Report to Development Permit Panel

Re: Application by Yamamoto Architecture Inc. for a Development Permit at
9431, 9451, 9471 and 9491 Williams Road

**Excerpt from the Minutes from
The Design Panel Meeting**

DP 13-630413
PLAN #3A
JAN 20 2014

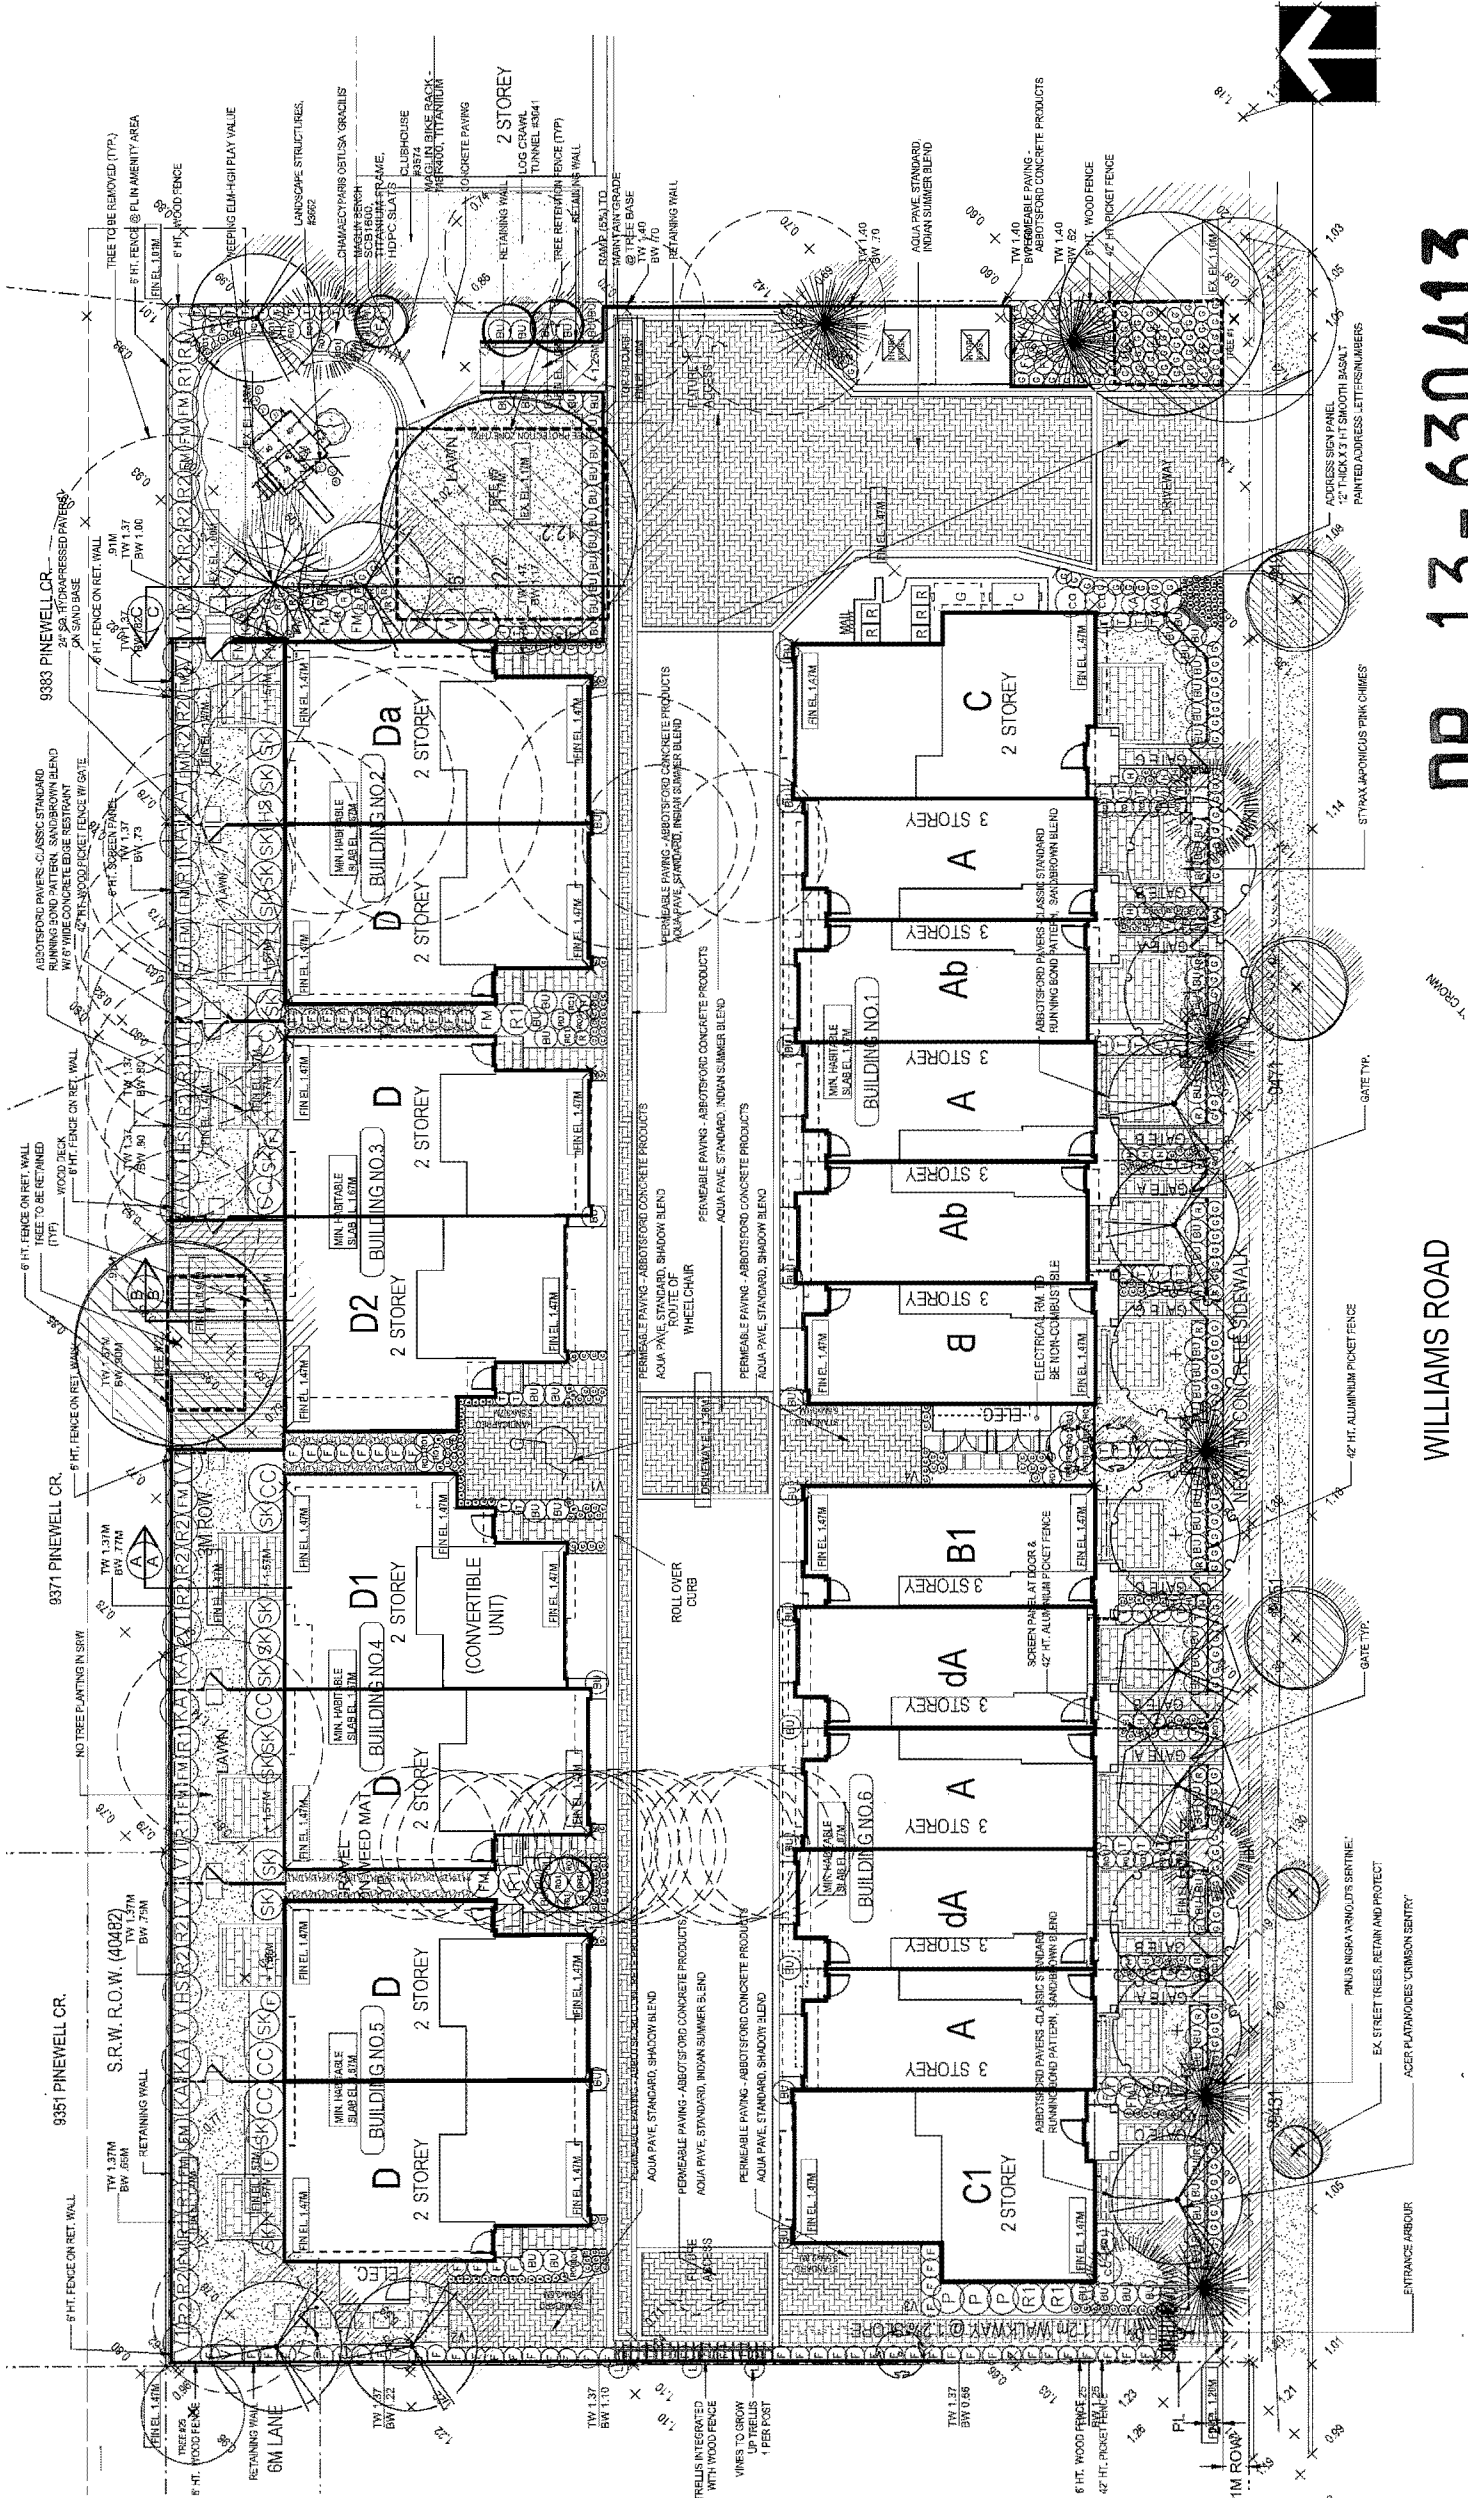
4. increase the lighting in the outdoor amenity space; limit the height of trees in the area up to 6 feet to enhance surveillance; ensure people entering the development can clearly see into the common outdoor amenity area;
Low planting along the base of the retaining wall provided to enhance surveillance in the outdoor amenity area. See sheet 3A and 3C.

5. the proposed ramp (which was mentioned by the applicant as a potential solution to address the change in grade between the drive aisle and the outdoor amenity space) may interfere with the gecko tree's roots; consider an appropriate solution, such as "flying" over the root system to minimize impact;
Proposed ramp from internal driveway to outdoor amenity area is located near the east property line with a distance of 4'-7" from the Tree Protection Zone at tree #5. See sheet 3A, 3C.

6. consider adding an arbour at the entrance point of walkways from the street;
A wooden trellis on stone pilasters is proposed 2m from the south property line at the entry of the pedestrian walkway. Permeable pavers at the "dead-end" of internal driveway to create a sense of arrival to the pedestrian. See sheet 3A, 3D.

9. concern on the survivability of proposed plant species to be planted in the narrow slots between the buildings; consider means to ensure survival;
Gravel to be proposed at narrow slots between buildings. See sheet 3A.

SCALE	1/8" = 1'-0"	SHEET NO.
DATE	JAN. 28, 2013	A4.1
DRAWN	KP	
CHECKED		
PROJ. NO.	1108

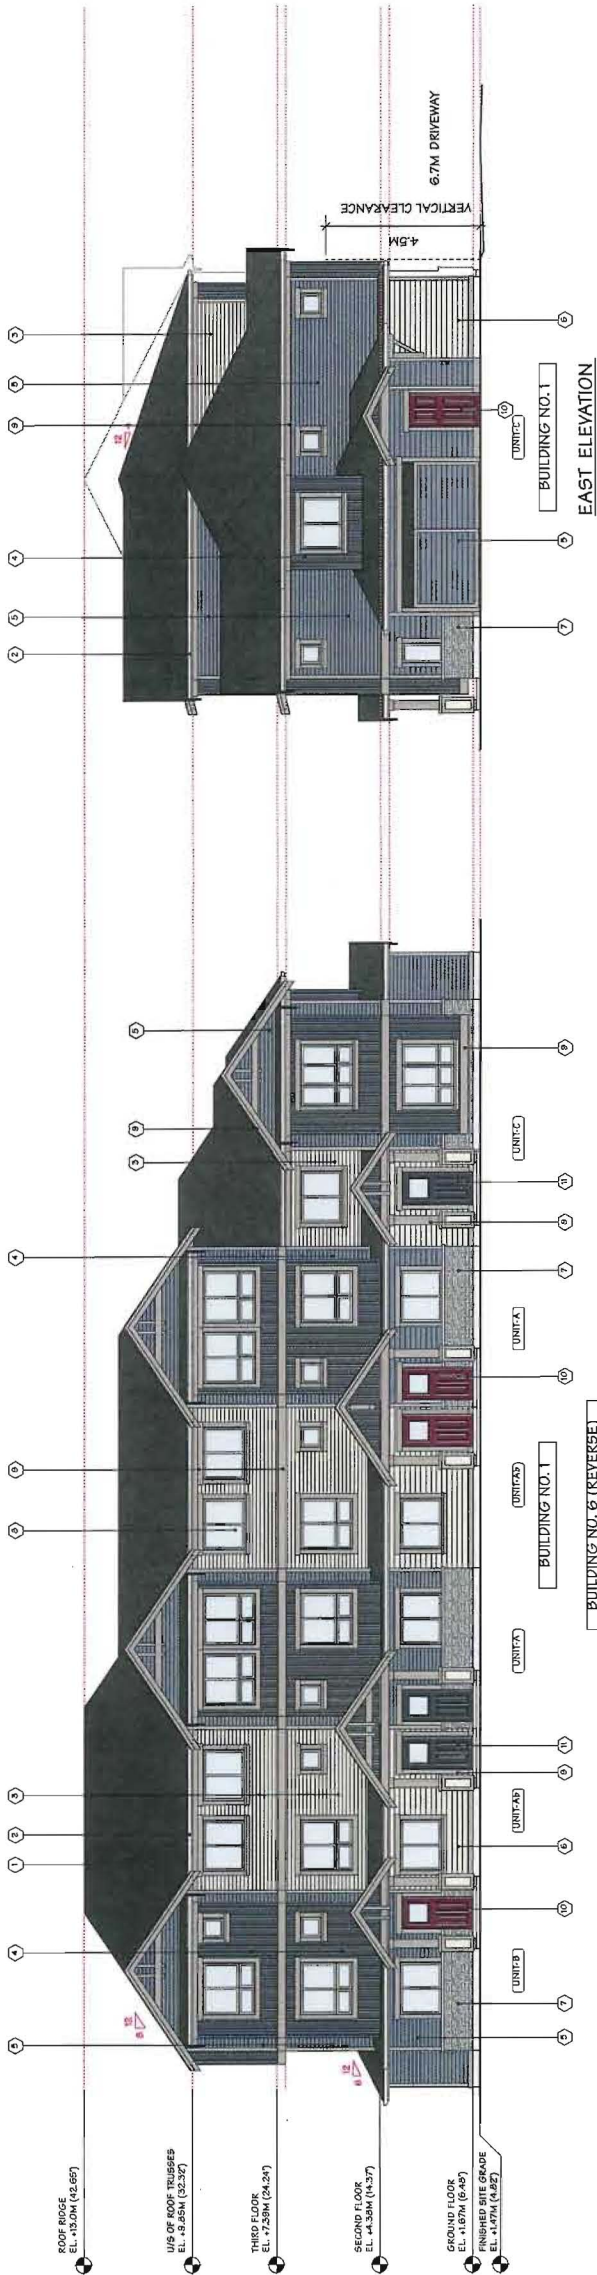
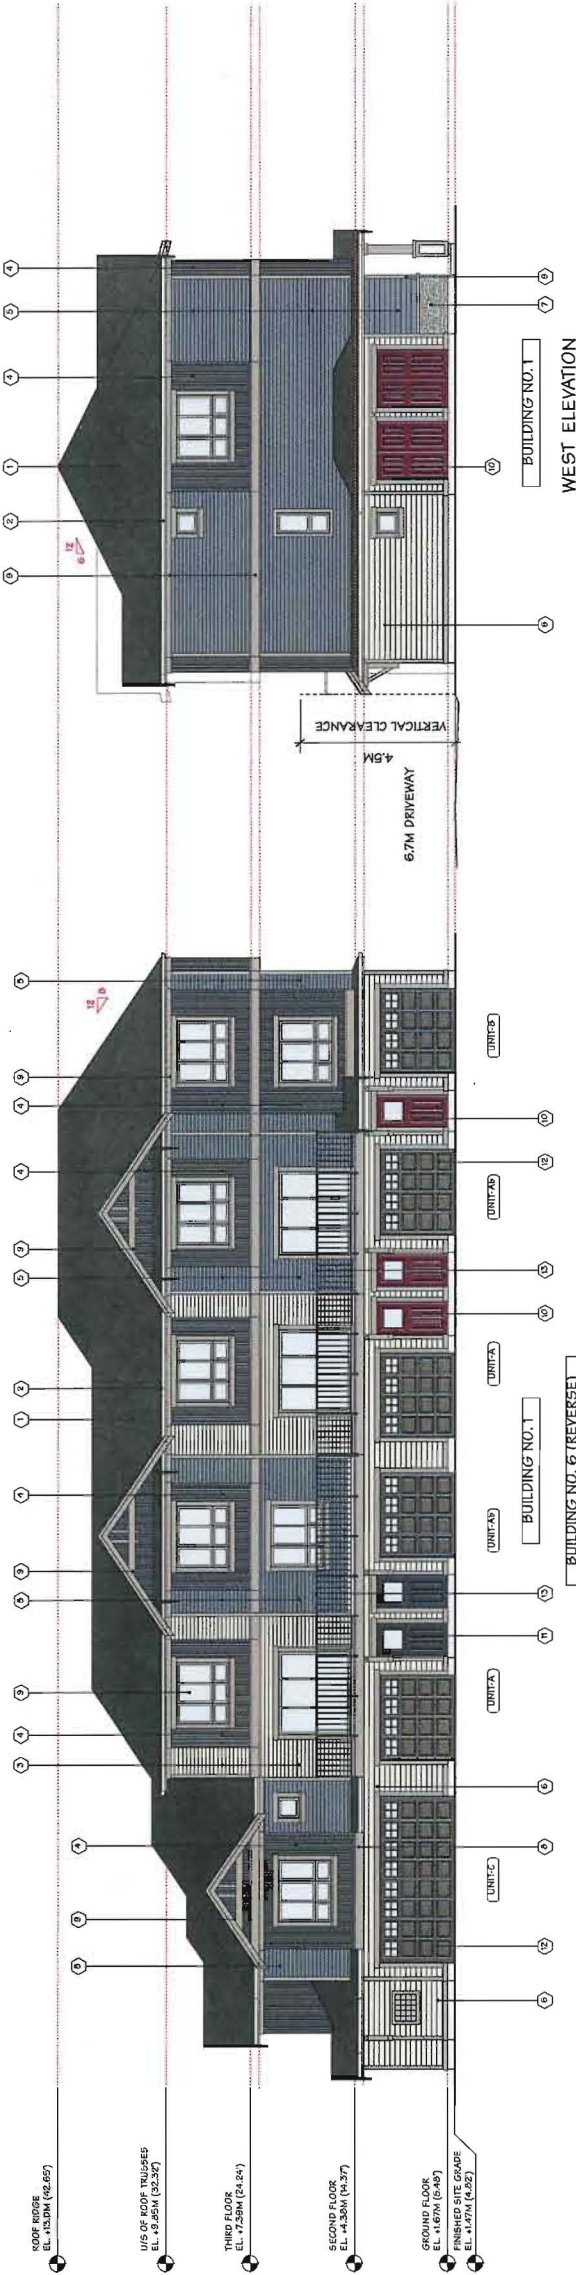
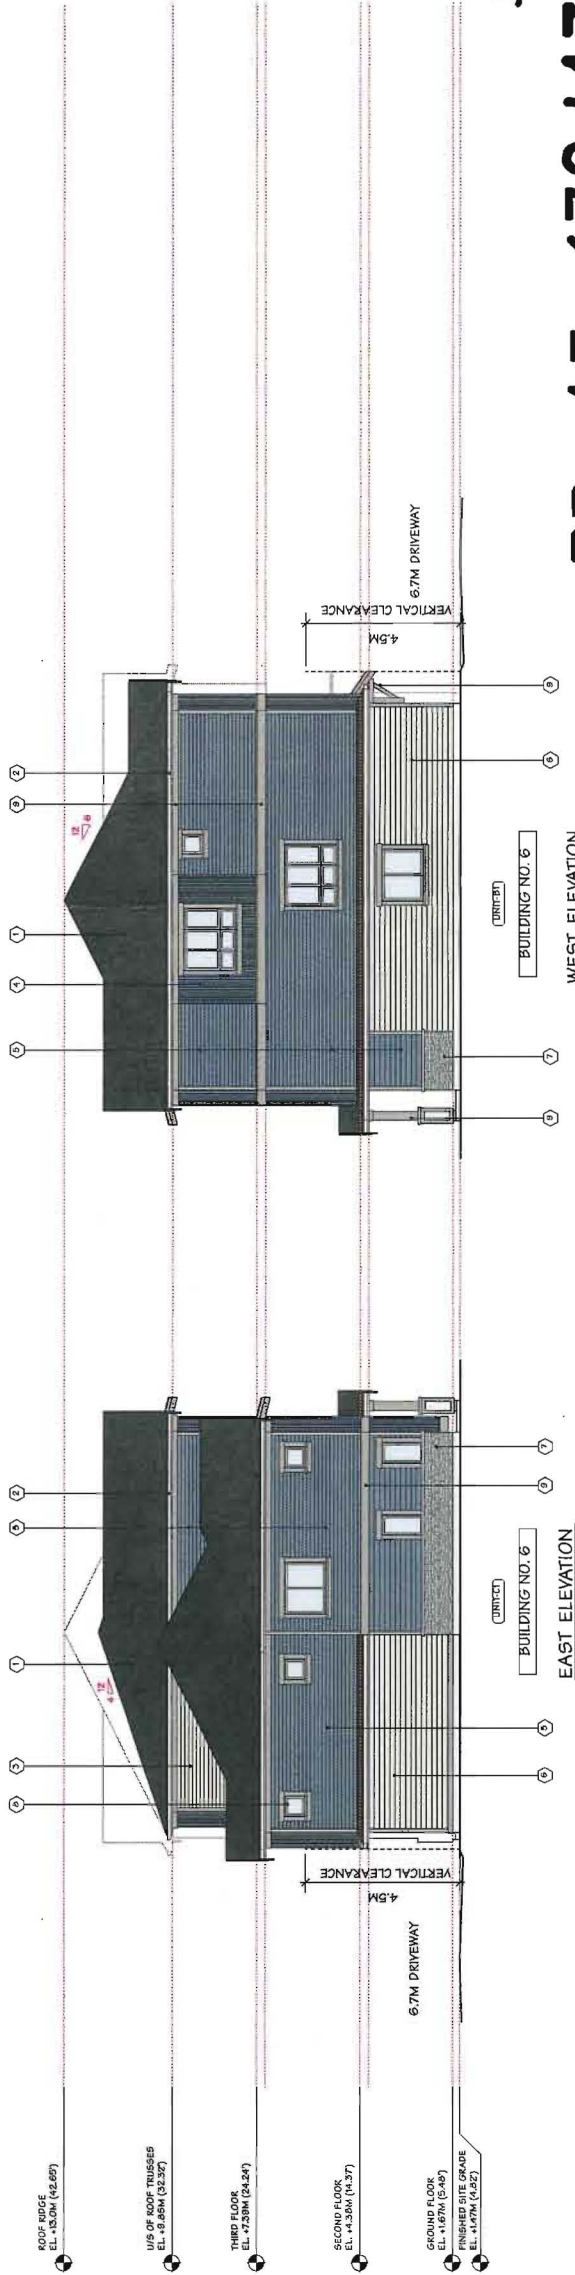
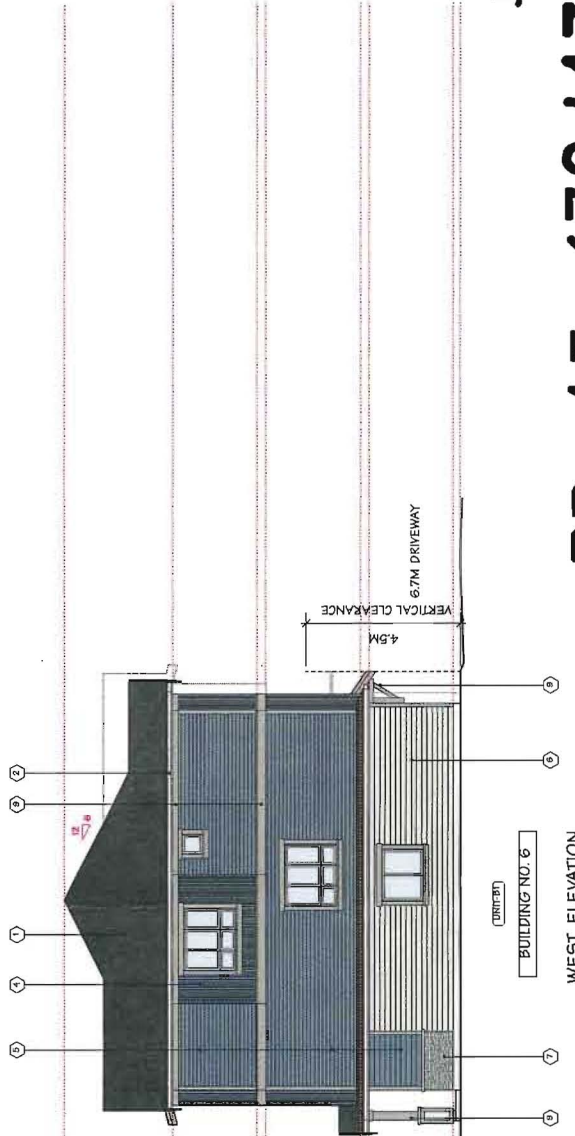
10. massing is successful; appreciate the stepping down of end units to blend well with adjacent single family developments;
Noted.
11. dark coloured materials appear drab; consider a lighter colour scheme to lighten the massing of the buildings;
Lighter color scheme revisited to emphasize the massing of the buildings. See revised colored elevations and material/color board. See sheet A4.1/4.2.
